| Project:  | 76 Priory Road, NW6 3NT<br>Mr. & Mrs. W. Grigull | 76PR   |
| Proposed: | Site Plan                                        | P001   |
| Status:   | Planning                                         |        |
| Date:     | January 2008                                     | Rev: A |

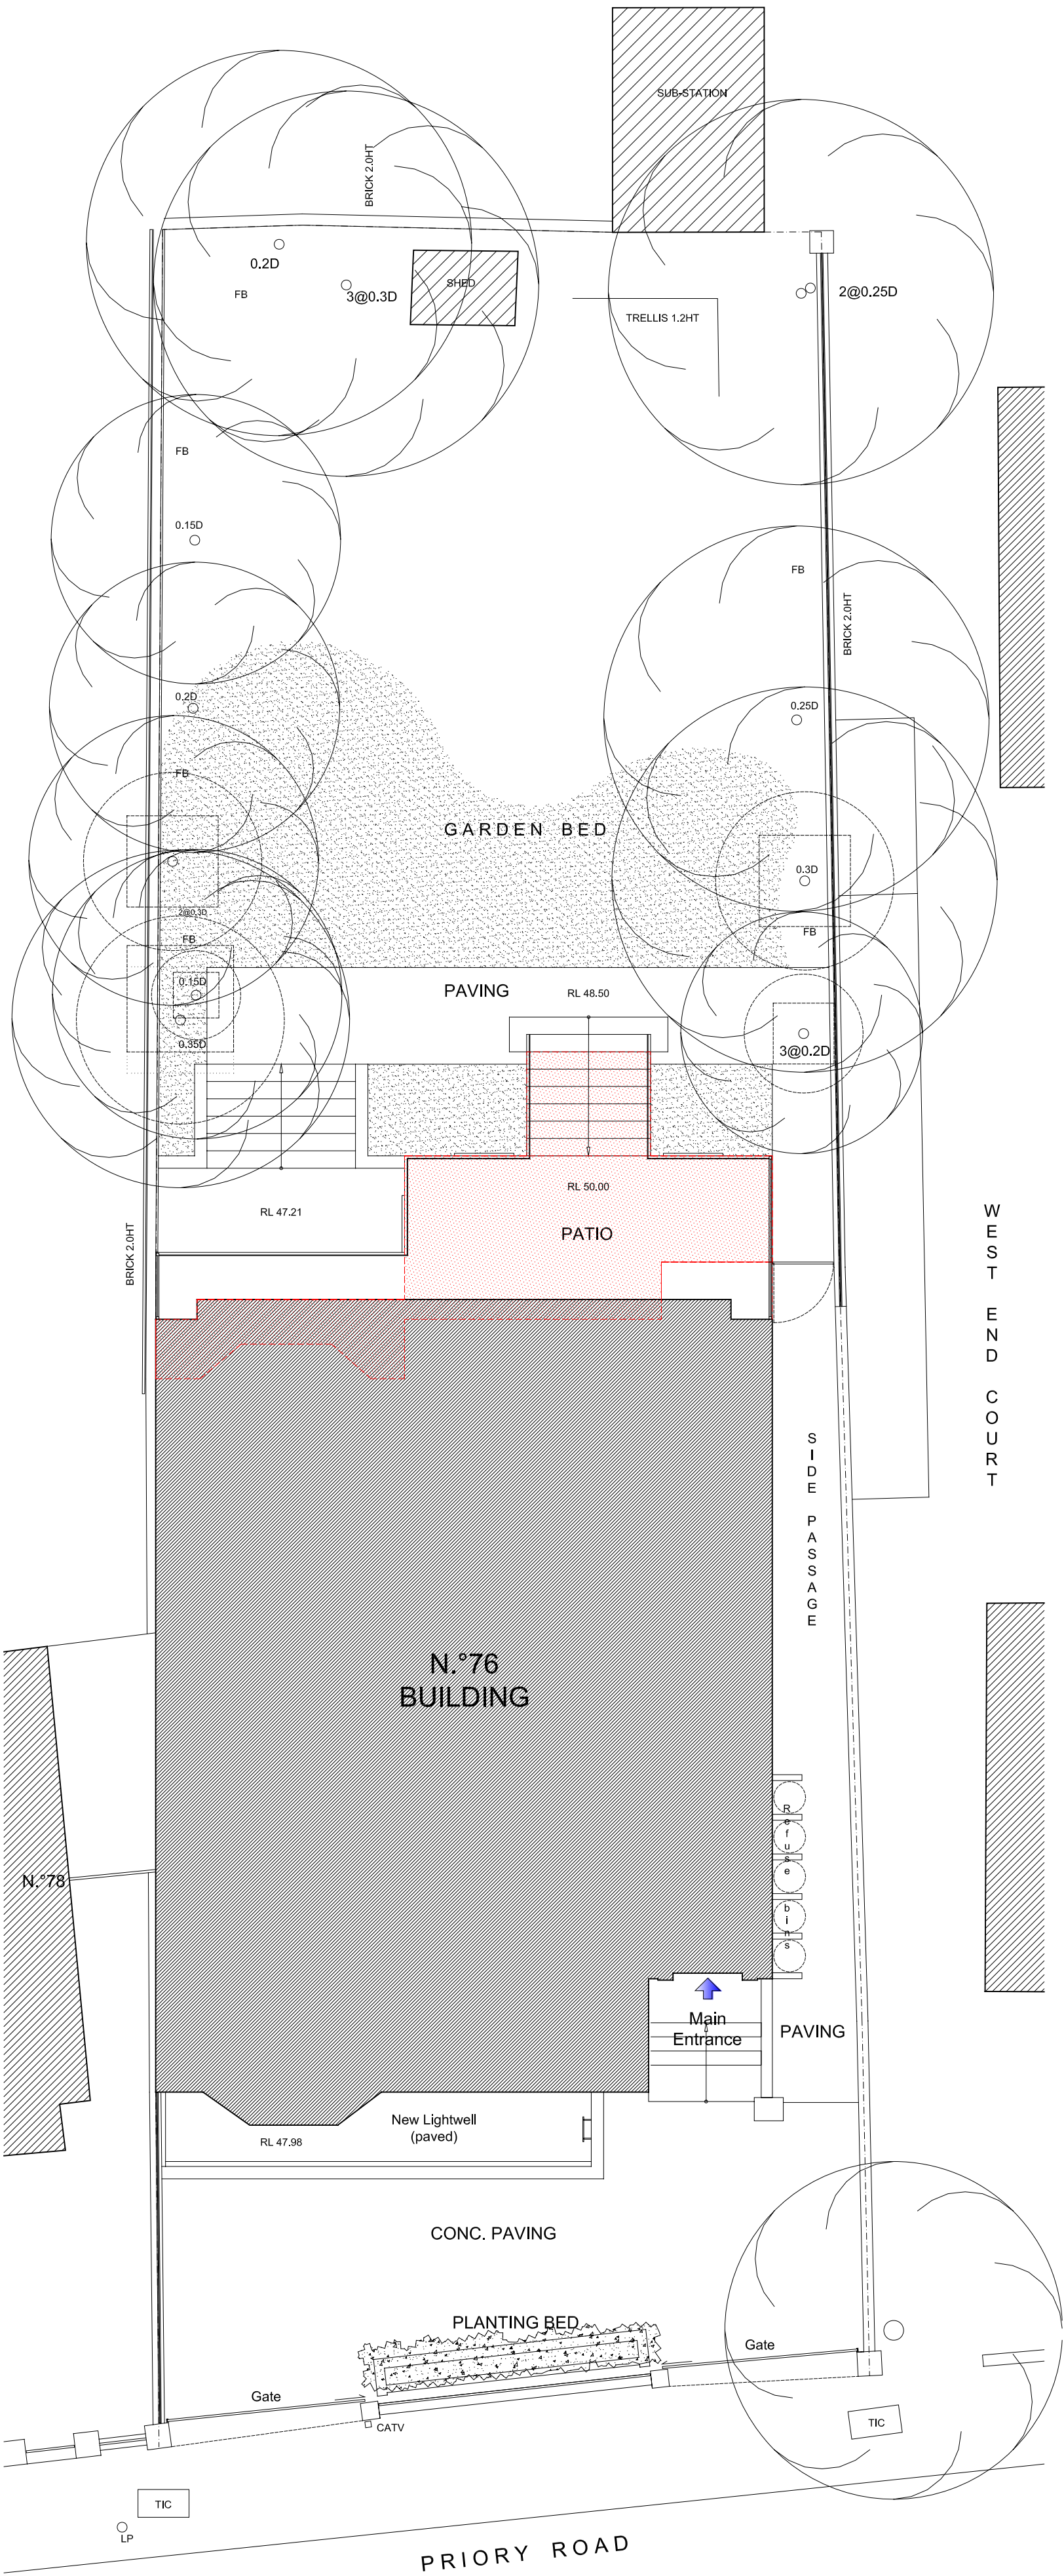
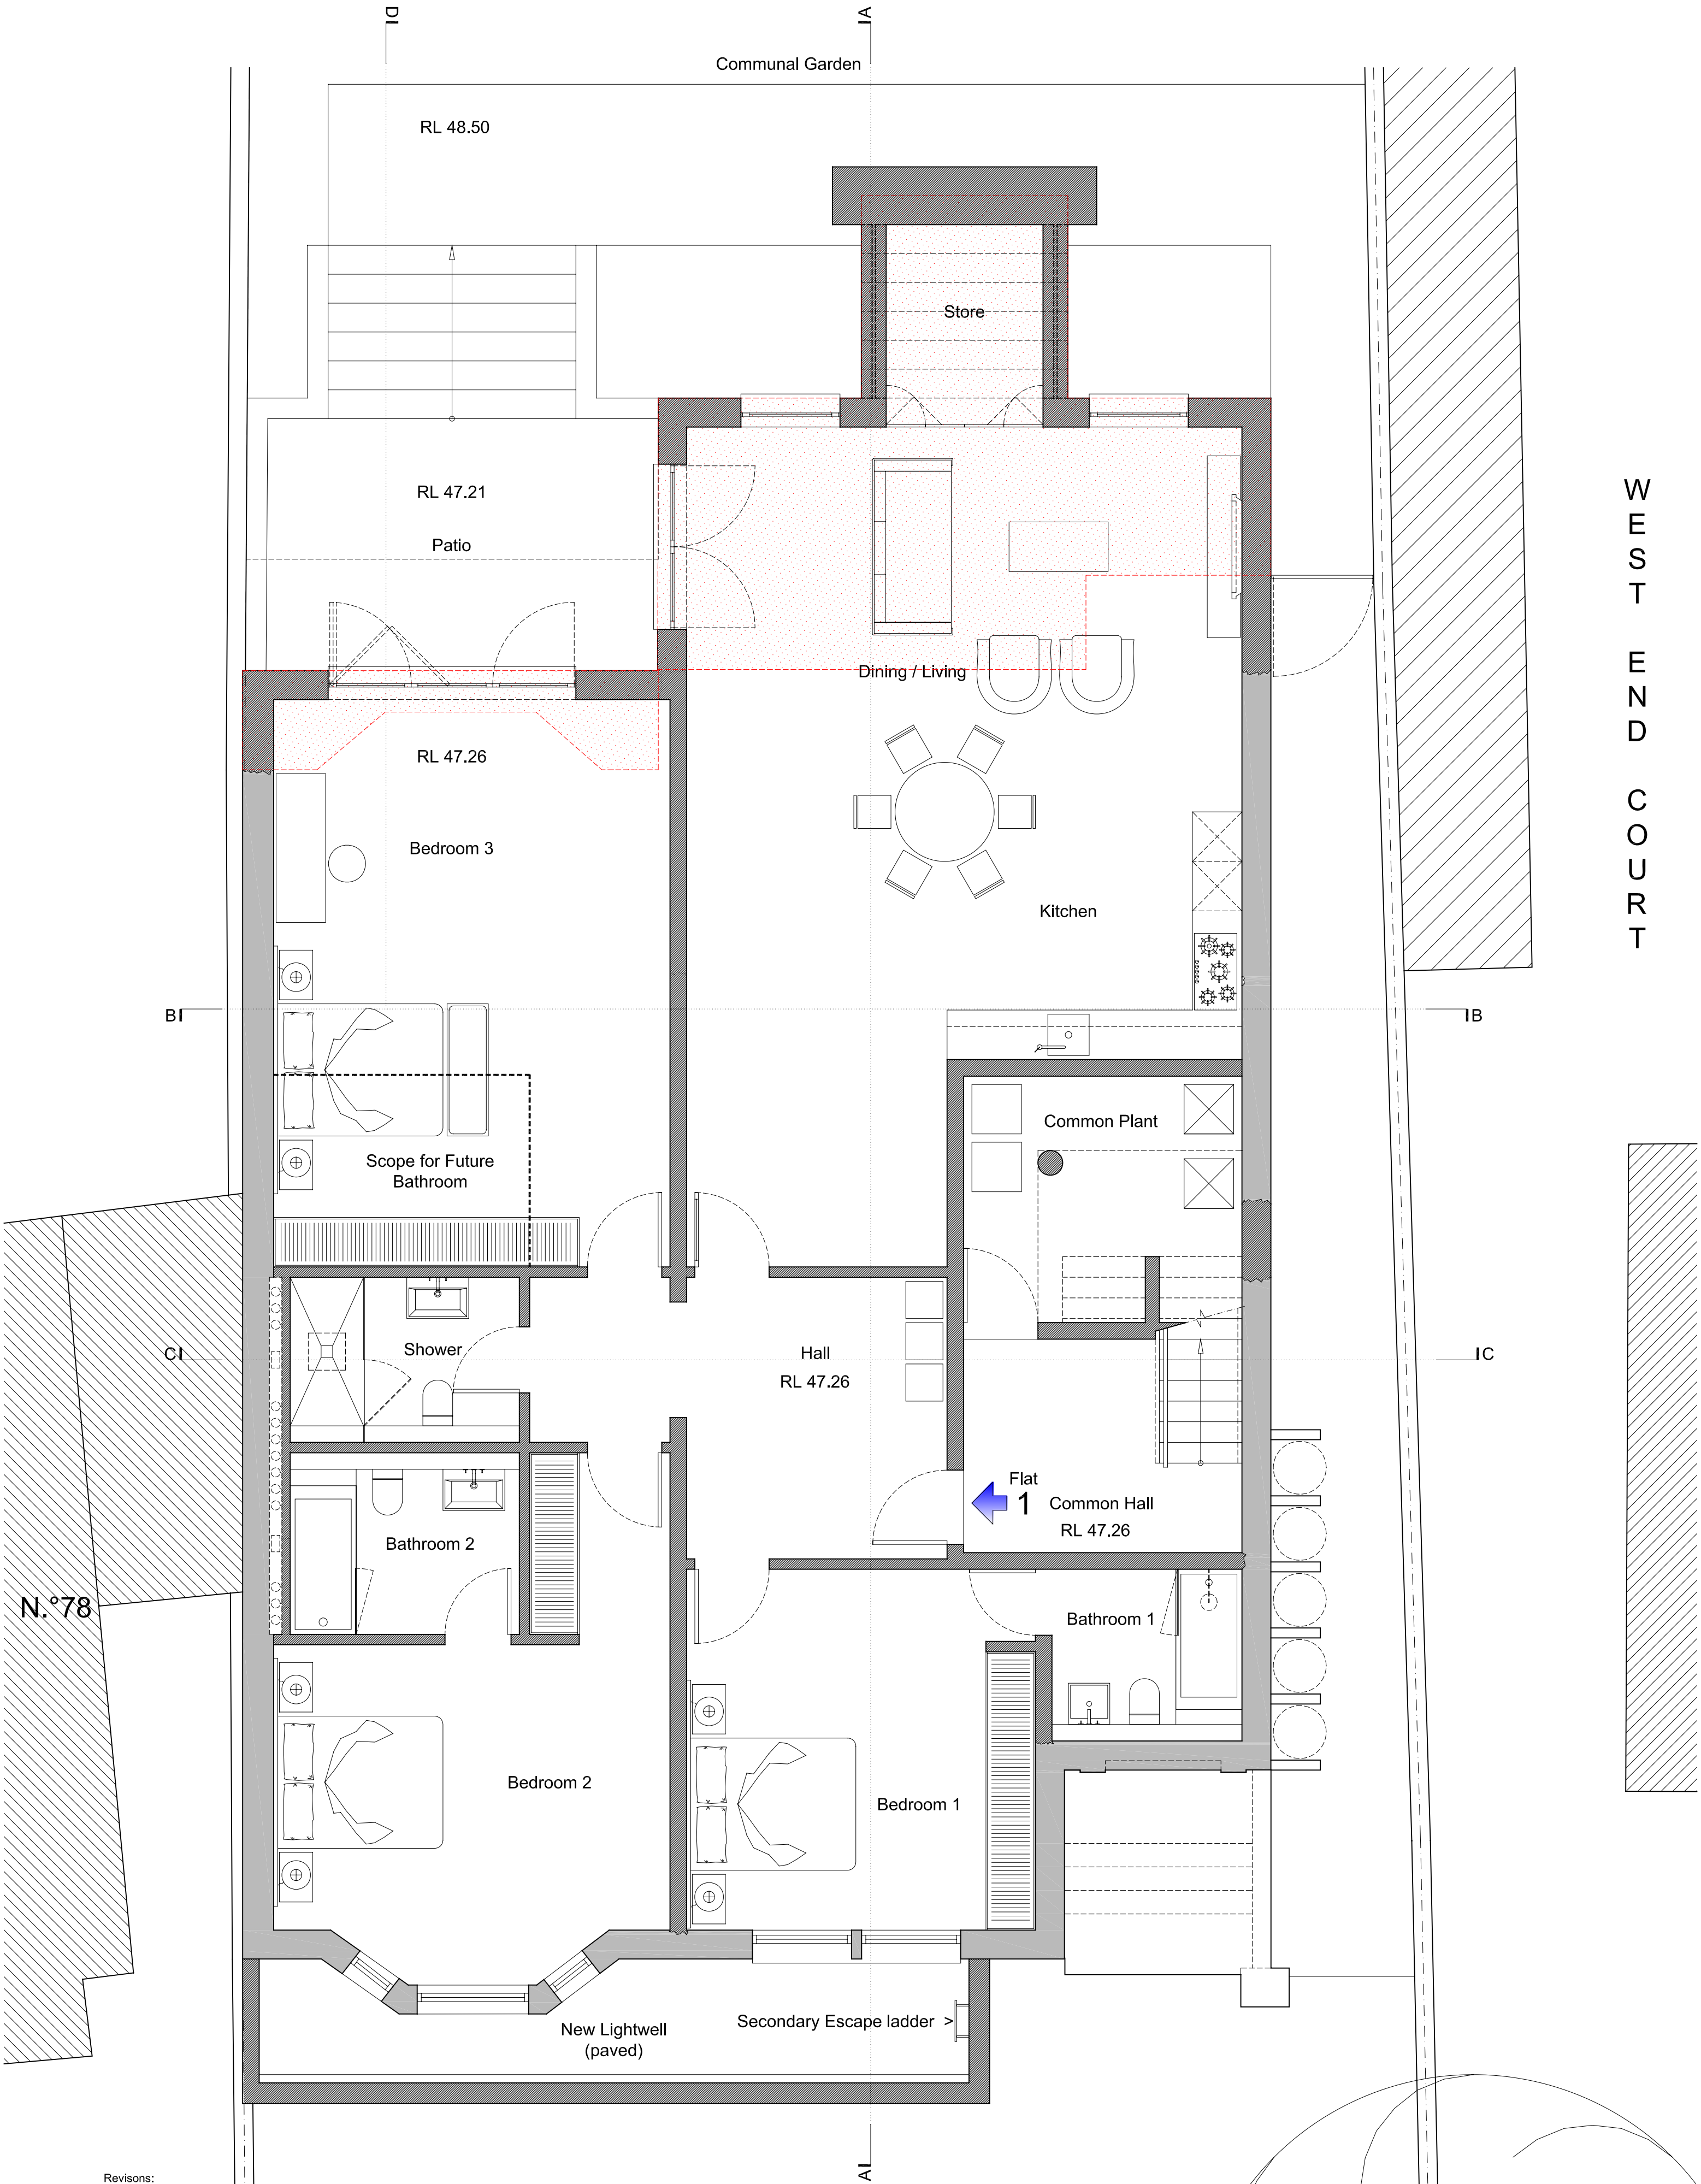
Rev A: 05-03-2008  
^Mansard roof on side entry annex revised to Hip roof form.  
^Chimney note added.  
^Railings to front light well removed & horizontal grill added.  
^Roof lights to sit flush with roof profile.  
^Rear dormer windows revised to sit within existing position.

| Proposed: | Lower ground plan                                | P002   |

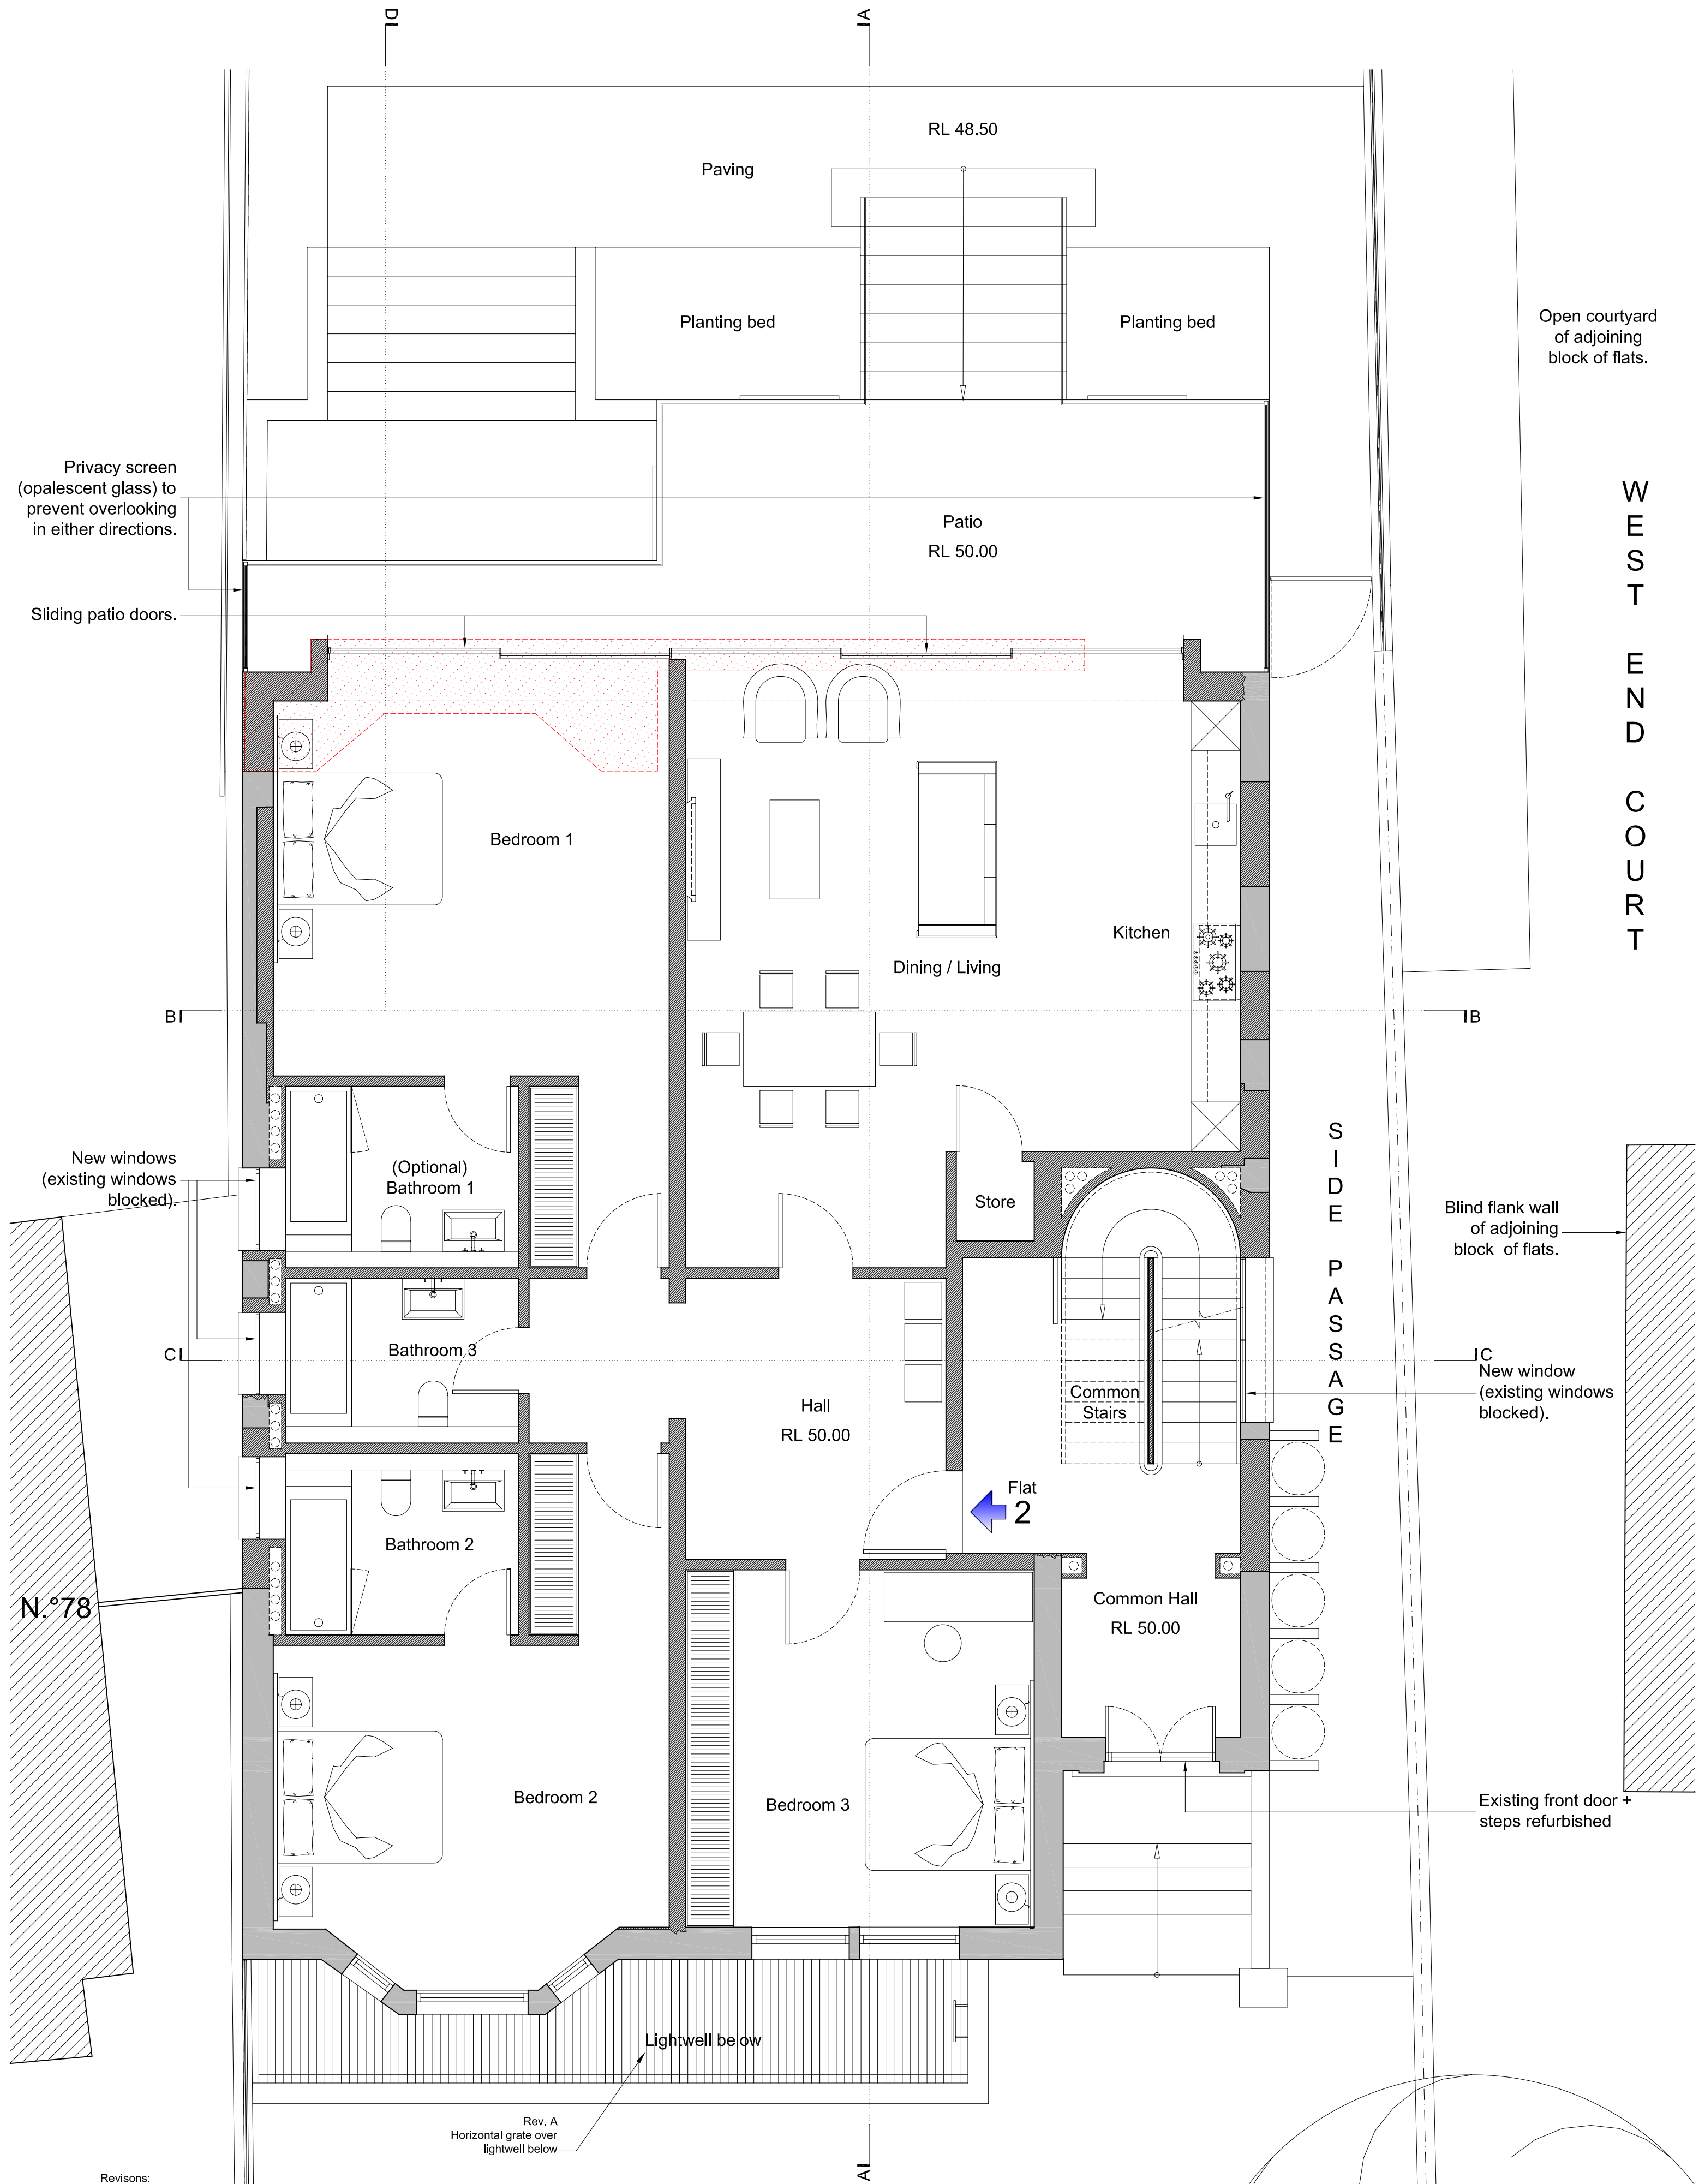
Revisions:  
Rev A: 05-03-2008  
\*Mansard roof on side entry annex revised to Hip roof form.  
\*Chimney note added.  
\*Railings to front light well removed & horizontal grill added.  
\*Roof lights to sit flush with roof profile.  
\*Rear dormer windows revised to sit within existing position.
